# Access Compliance Report

## Public Rights-of-Way

### (Curb Ramps)

Intersection ID: 47851	Main Street: CACTUS_VALLEY_RD	Cross Street: SERAPE_RD	Location: NW
ADA ID: DB2AA2F78194	Ramp Type: PerpDiag	Initial Pass/Fail: Fail	Overall Compliance: No
		Severity Score: 8.75

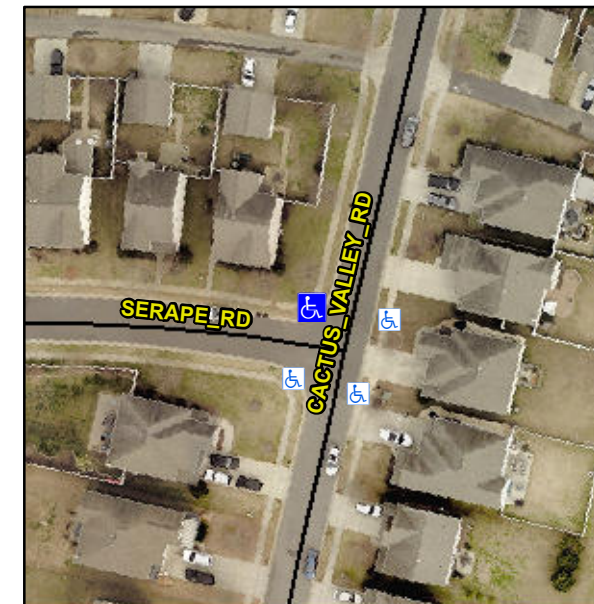
**Not Found, R304.5.1**

Compliance	Description	Data	Compliance	Description	Data
N/A	Ramp Length (in)	65.0	Yes	Ramp Slope (%)	5.2
No	Ramp Width (in)	45.0	Yes	Ramp XSlope (%)	1.7
N/A	Flare Type LT	N/A	N/A	Flare Type RT	N/A
N/A	Flare Slope LT (%)	N/A	N/A	Flare Slope RT (%)	N/A
N/A	Flare Traversable LT?	N/A	N/A	Flare Traversable RT?	N/A
N/A	Landing Length (in)	N/A	N/A	DWS Provided?	N/A
N/A	Landing Width (in)	N/A	N/A	DWS Contrast?	N/A
N/A	Landing Slope (%)	N/A	N/A	DWS Length (in)	N/A
N/A	Landing X Slope (%)	N/A	N/A	DWS Full Width?	N/A
N/A	Landing Curb? (Y/N)	N/A	N/A	DWS Offset (in)	N/A
N/A	Shared Landing?	N/A			
N/A	Gutter Ponding?	N/A	N/A	Gutter Slope (%)	N/A
N/A	Gutter Lip Ht (in)	N/A	N/A	Gutter X Slope (%)	N/A
N/A	Painted X Walk1?	No	N/A	Painted X Walk2?	No
	X Walk 1 Direction	To SW		X Walk 2 Direction	To SE
N/A	X Walk 1 Width (in)	N/A	N/A	X Walk 2 Width (in)	N/A
	X Walk 1 Slope (%)	0.5		X Walk 2 Slope (%)	2.5
	X Walk 1 X Slope (%)	1.5		X Walk 2 X Slope (%)	0.5

**Remove & Replace Curb Ramp With Two New Directional Ramps or Equivalent.**
